Machines

Machine	TASKI swingo XP
Subassembly	Electronic

USB Cable

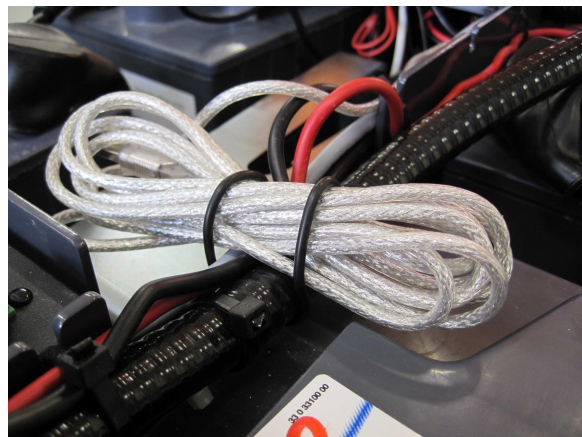
For a more comfortable data exchange a new USB cable will be integrated into the machine. The cable is connected to the data interface of the electronic.

The interface cable can't be made accessible from outside ex factory. This would require a new certification of the machine.

By making the interface cable accessible from outside it has to be paid attention where to position it (mechanical damage as well as splash water protection)!

Description	Order number	Remark
USB Cable 3m	4129688 (18603-93)	New Spare Part Number

We recommend updating existing machines with the new USB cable if required.
